City of Albuquerque Environmental Planning Commission

Staff Report

CASE #: SP-2026-00044

CASE SUMMARY: This request is a Site Plan – EPC for the Albuquerque Bernalillo County Water Utility Authority (ABCWUA) to develop a water reuse system (i.e., major utility use) in the Mesa del Sol Community Master Plan Employment Center I boundaries.

Attachment B: Updated Sheet C-304 and new Sheet 304A

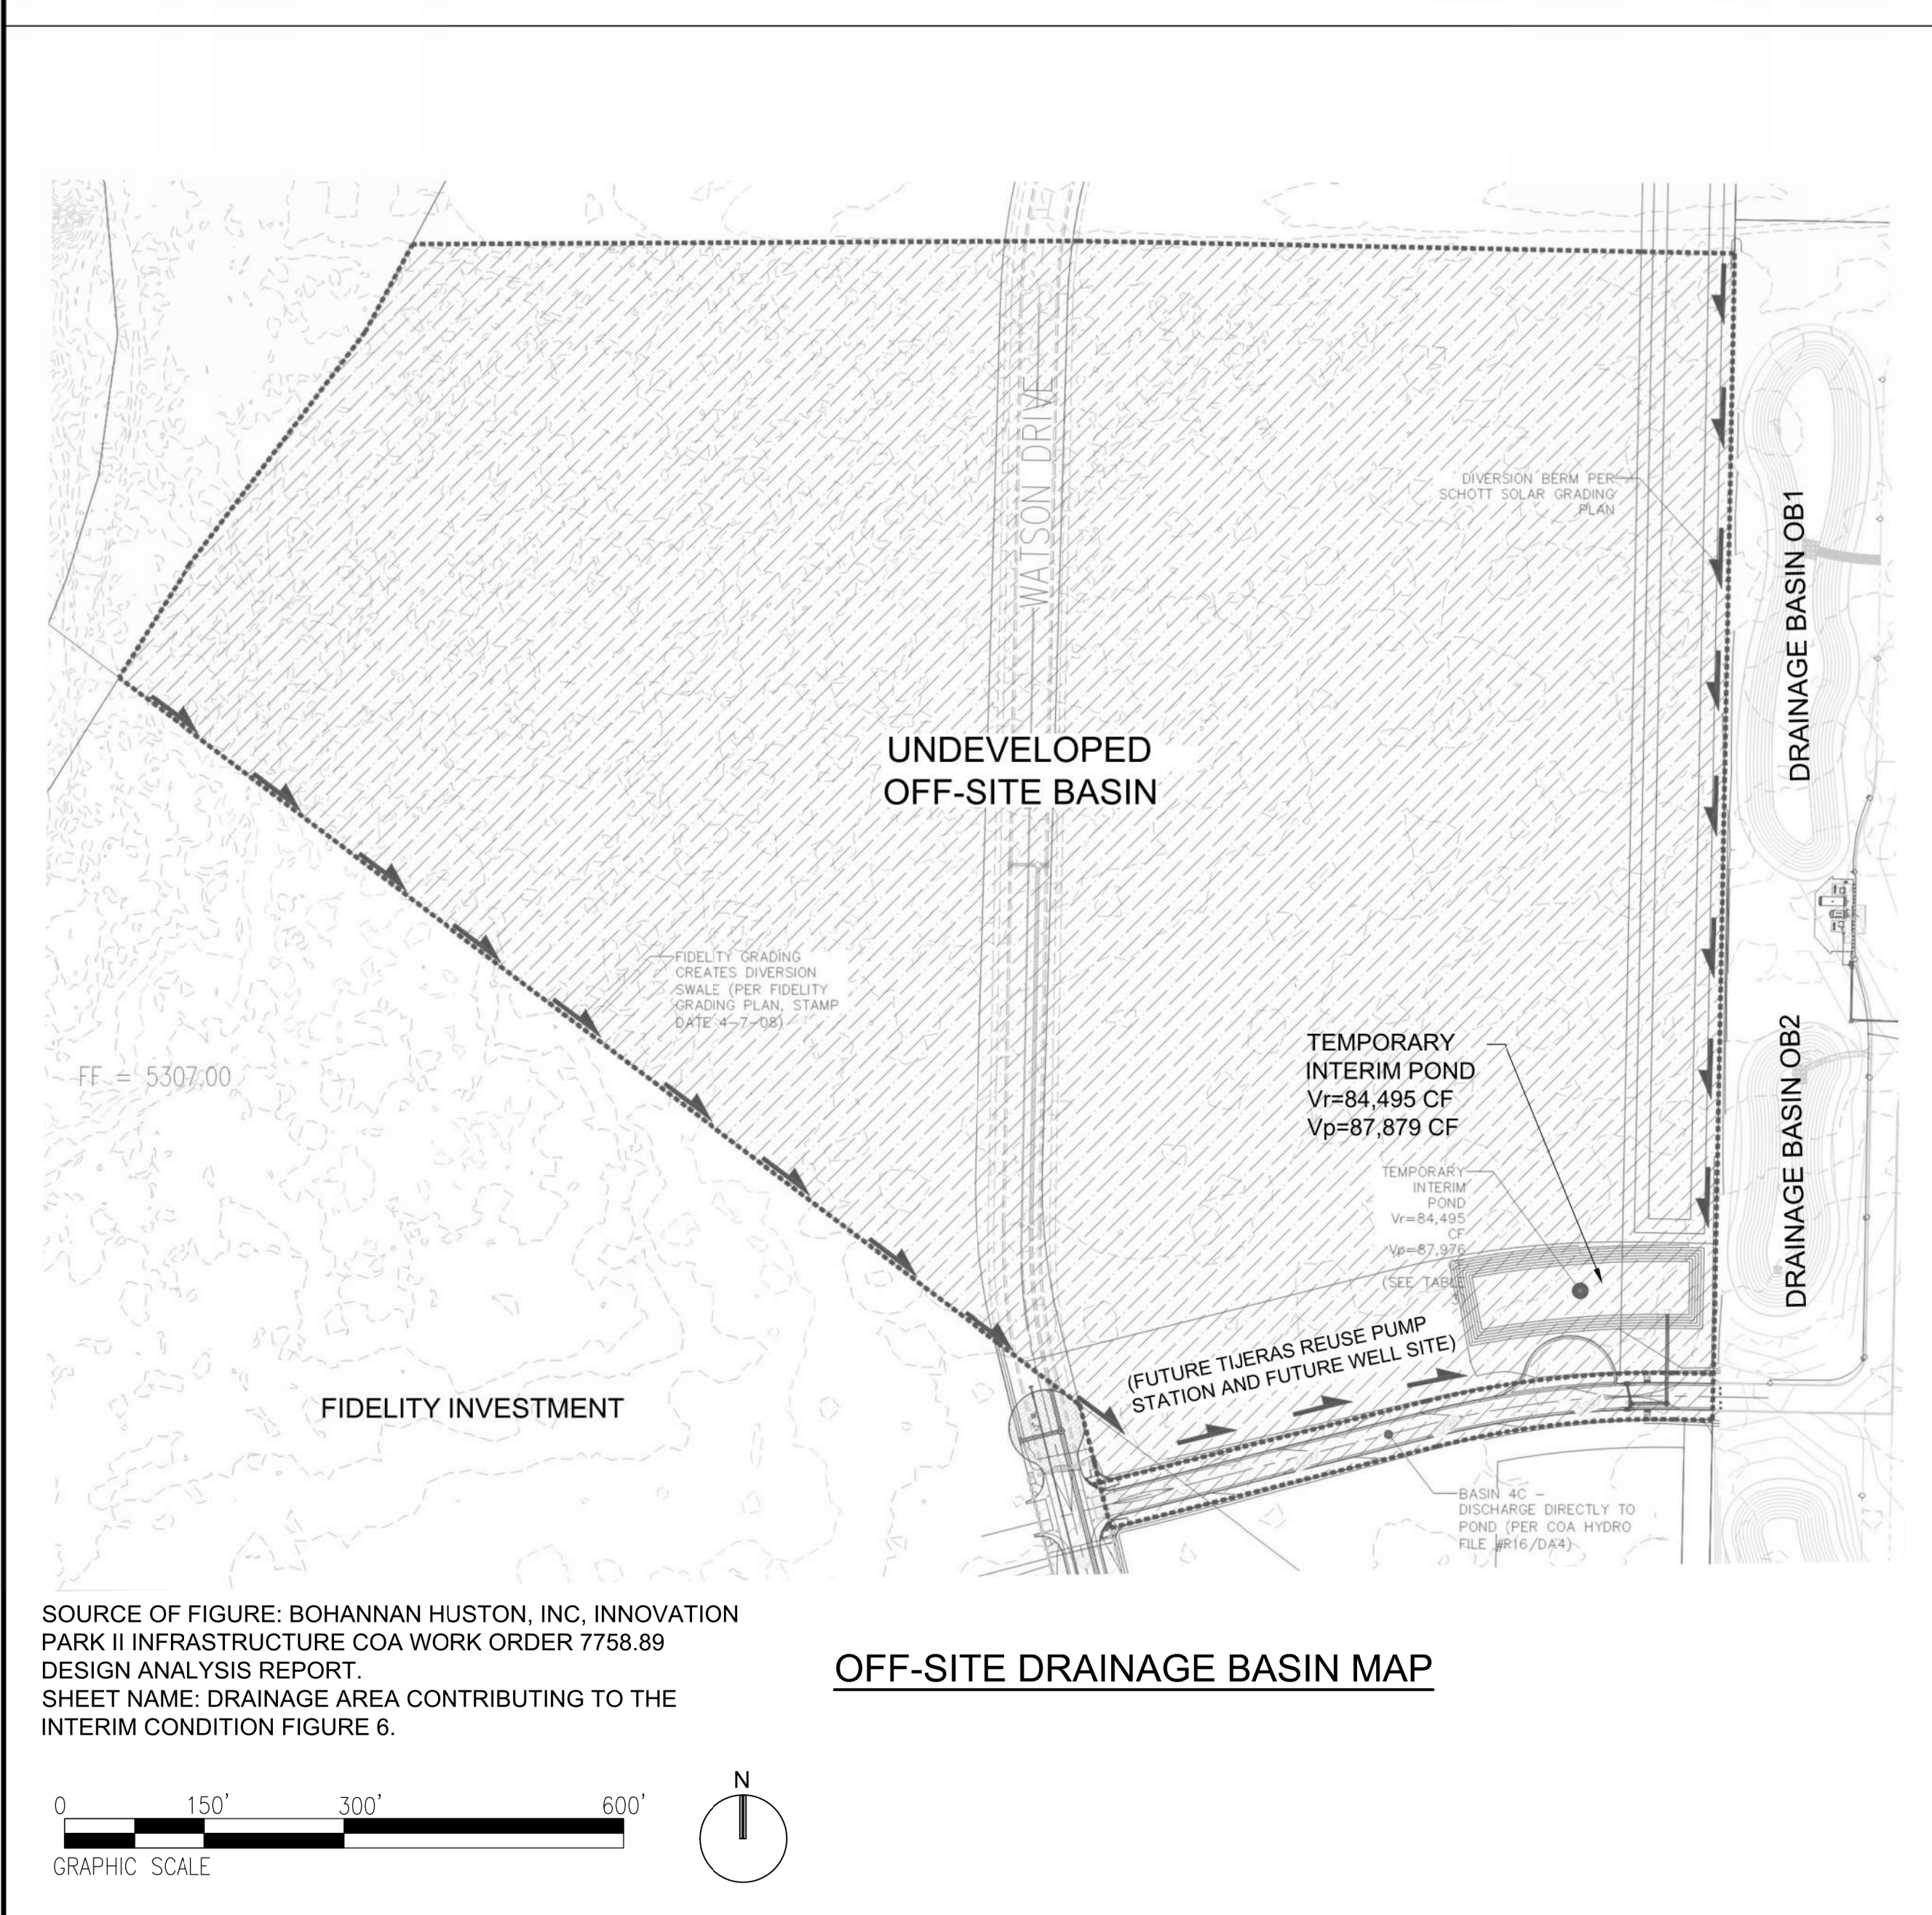
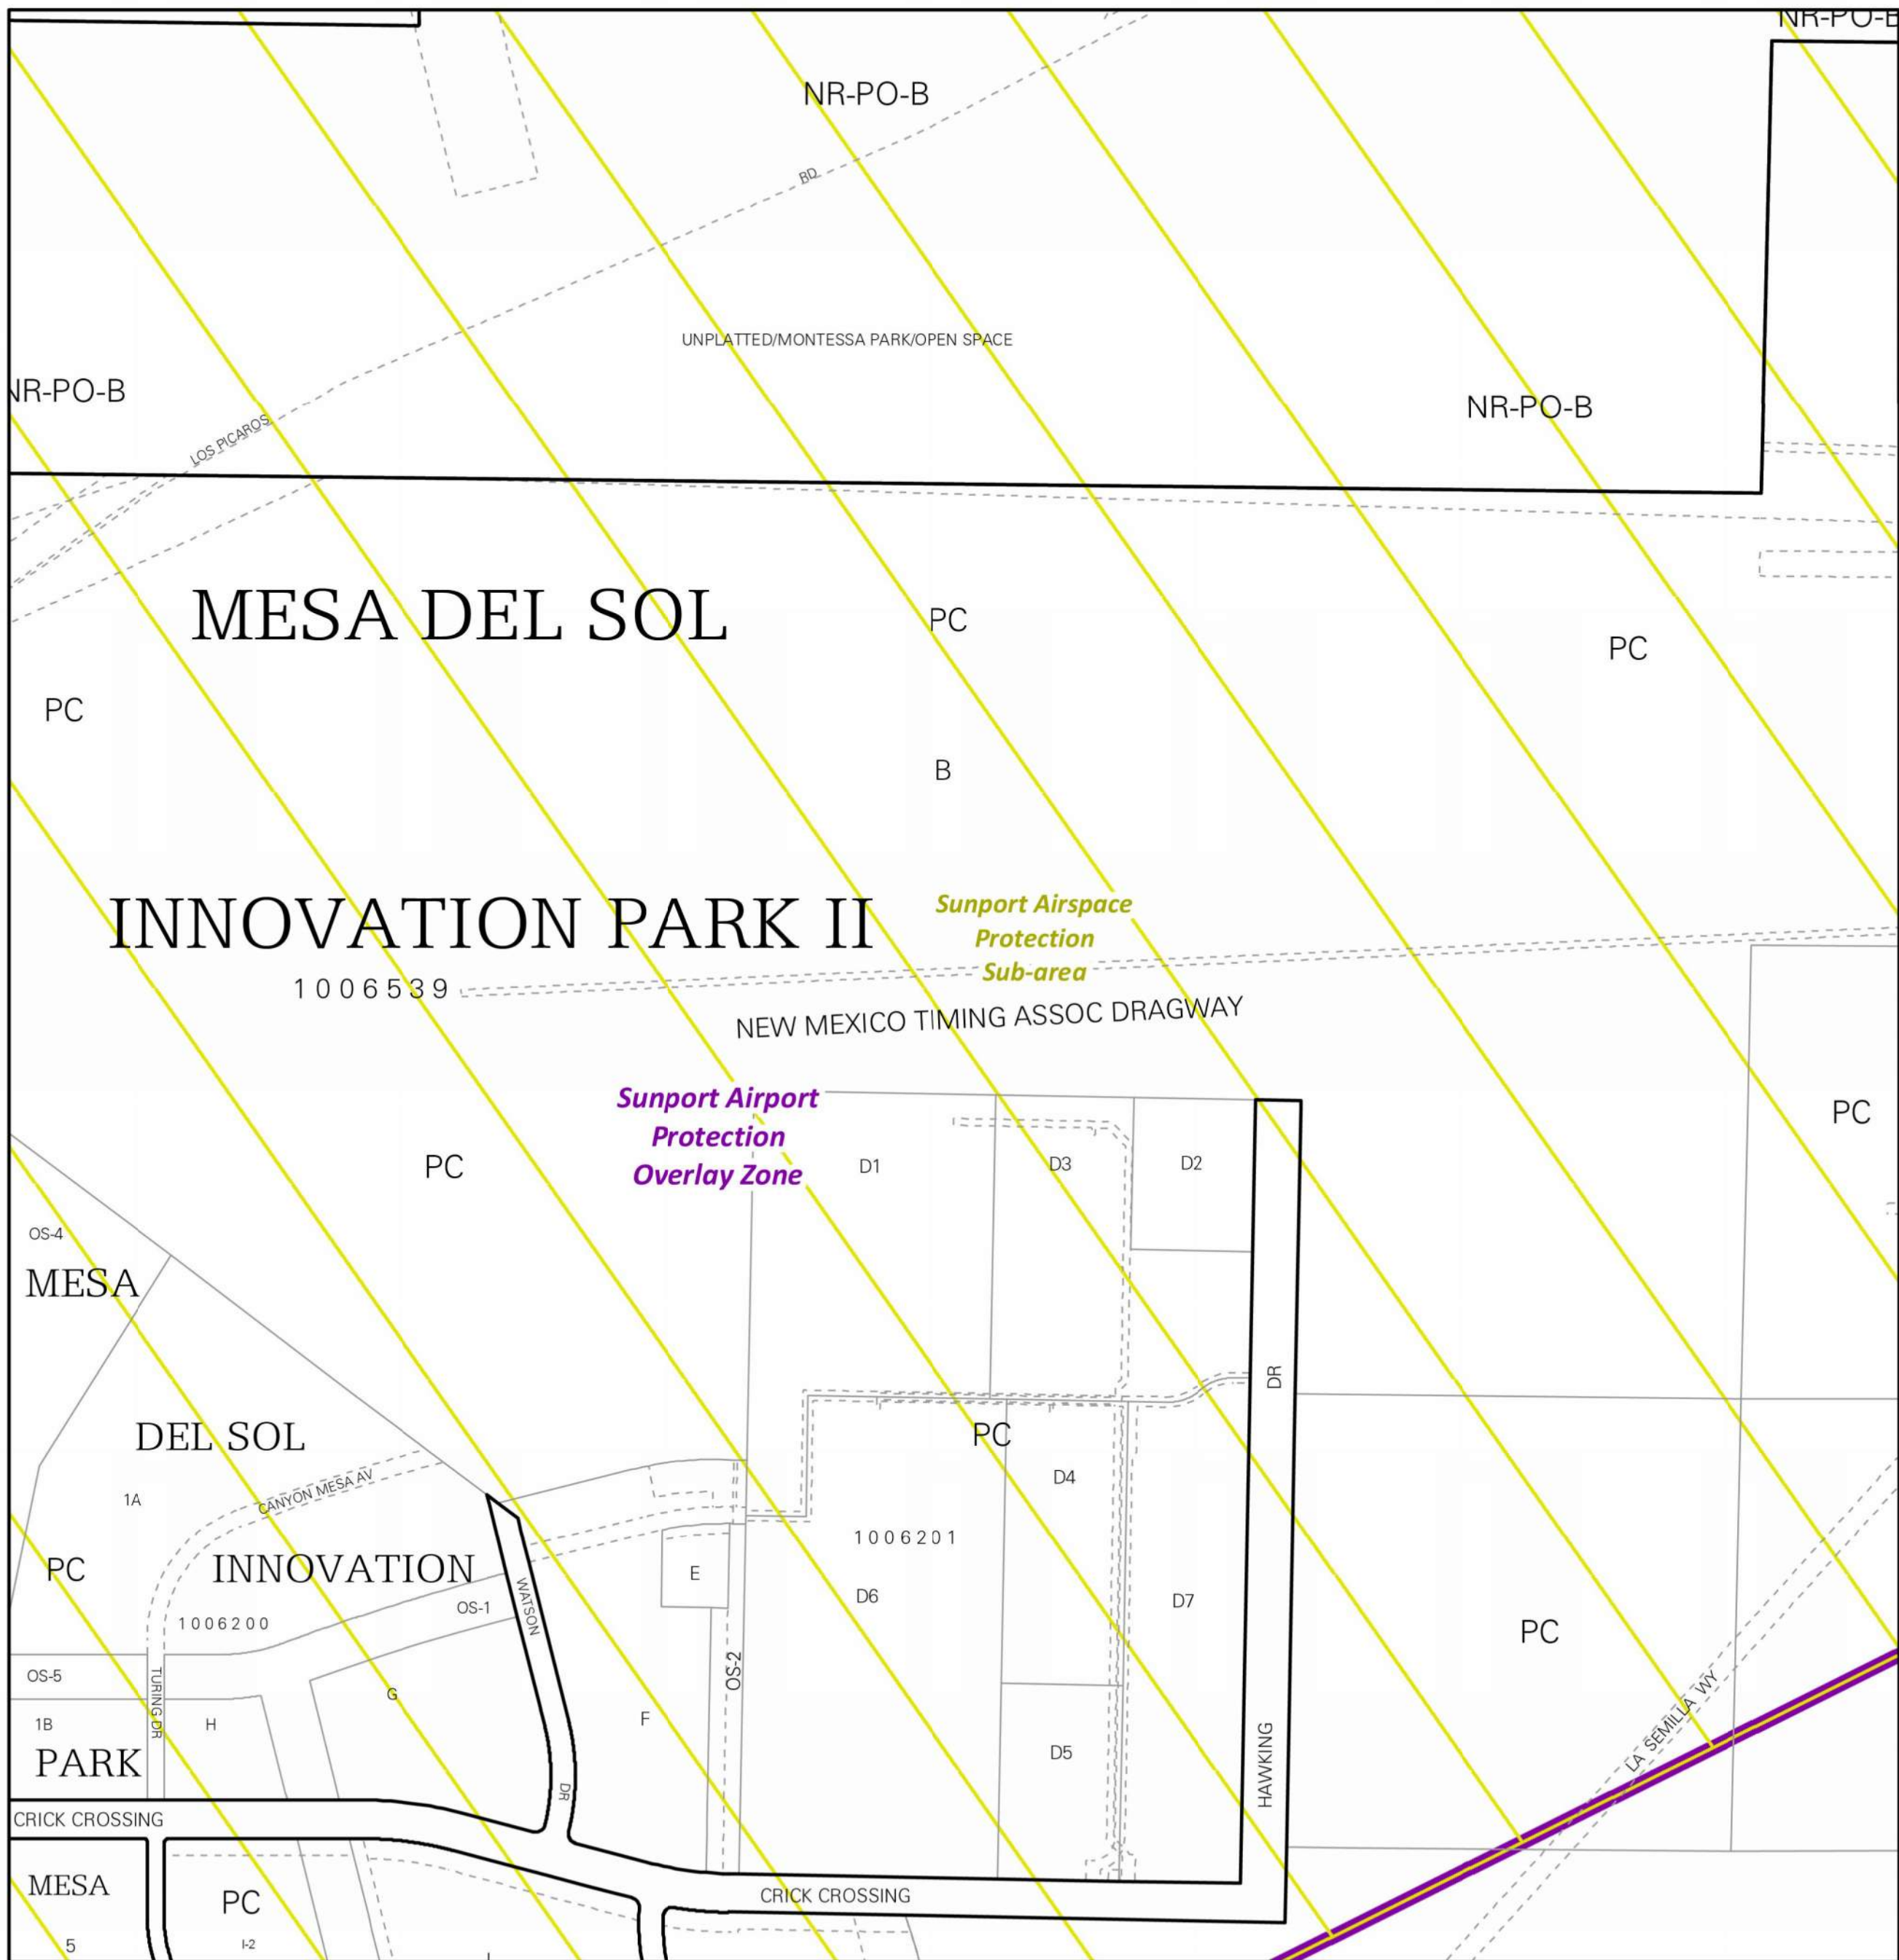
5. Please add a note under Grading Notes. "Side slopes need to be stabilized with Native Grass Seed (per City Spec 1012) with Aggregate Mulch or equal (Must satisfy the "Final Stabilization criteria" CGP 2.2.14.b.)".	The requested note has been added to the Proposed Site Grading section of the Drainage Narrative on Sheet C-304.
